Service Bulletin

Revised Information: Release of DX-D 100 / DX-D 100 Wireless System Version 4.3.10

DD+DIS184.13E

Figure 1

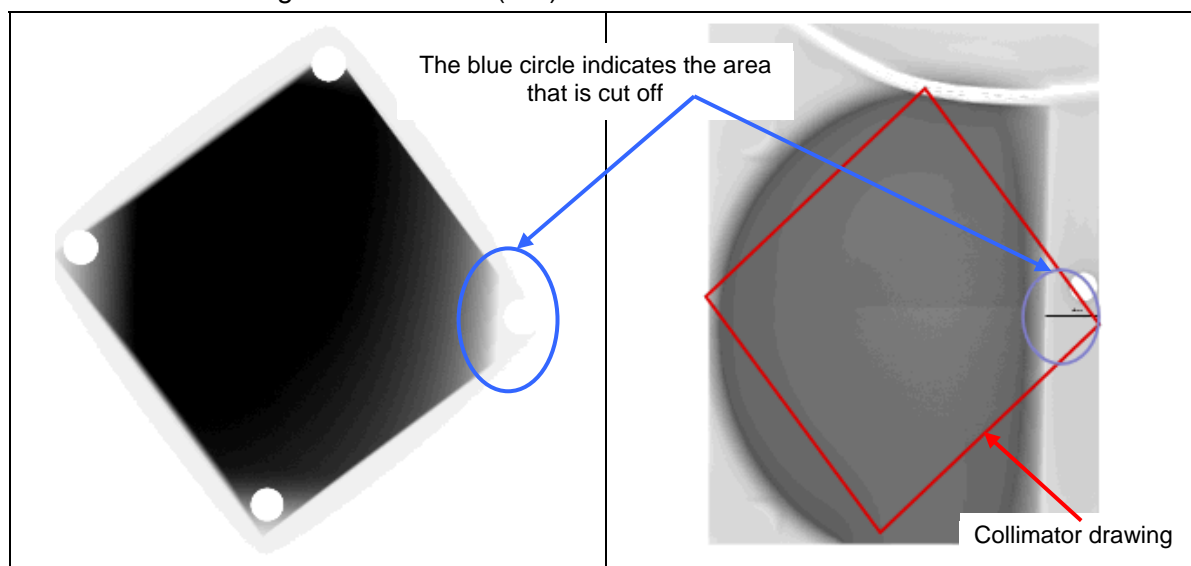
Symptom When Source Image Distance (SID) is short and collimator rotated by approx. 45° the light field does not match up with X-ray field. Part of Field of View (FOV) is not exposed (see Figure 1).

The issue appears when the user wants to use SID smaller than 100 cm.
The reason is the angle of the anode (12°).

Cause This is due to the limitations, specifications and performances of the X-ray tube.

Solution It is not possible to solve the issue when using the same tube with SID 100 cm.
Advice the user to use an SID higher than 100 cm.

Figure 3

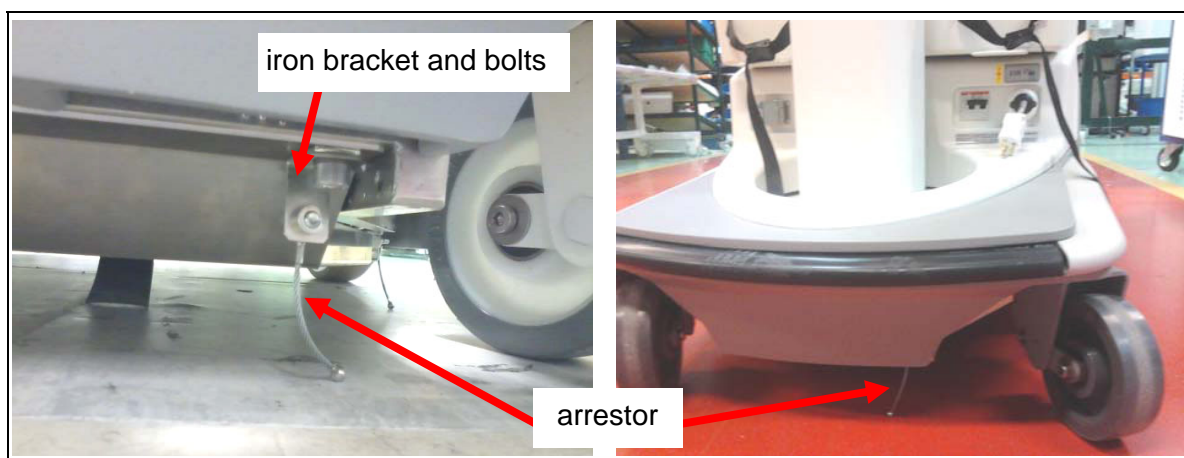
3.1 Replacing the discharging strap (HQ_1204190001)

To improve the electrostatic discharge the current strap for discharging the equipment can be replaced by a metallic arrestor, fixed with an iron bracket and bolts.

- (1) Order the Arrestor Strap Kit. Refer to section 2.
- (2) Mount the arrestor at the front side by the means of the iron bracket and bolts.

Figure 4

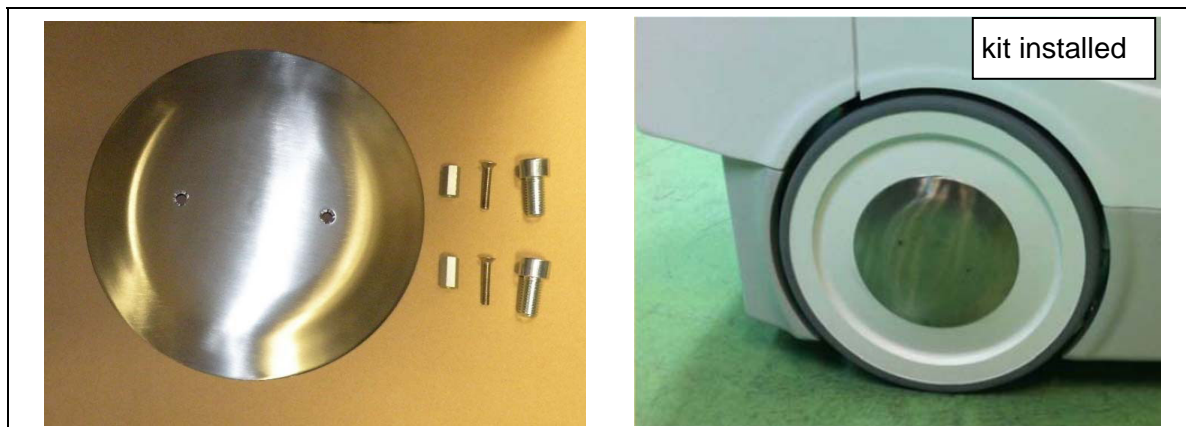
3.3 Mounting the stainless steel hubs (FR1302280012)

- (1) Order Hubcap kit(s). Refer to section 2.
One kit consists of **one** hubcap and the hardware needed for installing.
- (2) Mount the stainless steel hubs at the rear wheels. The installation instruction is part of the delivery.

Figure 5: Old revision Inverter Battery Charger 1
A3533-04

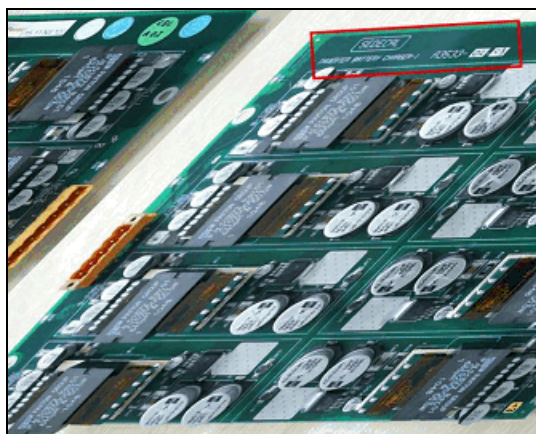
The replacement of X-Ray charger boards and Motor charger boards is only necessary in case of:

- Issues like short circuit or smoke at the boards during charging the batteries.
- DX-D 100 wireless with serial number lower than A5411000302
- Boards serial number revision is below E. The revision of the charger boards can be identified on the boards itself (see figures below).

Replacing battery charger boards is described in the DX-D 100 / DX-D 100 Wireless - Mobile X-Ray Unit - Service Manual in section “Troubleshooting”, chapter “Batteries and Chargers”. The document is available in the Agfa Healthcare Library:
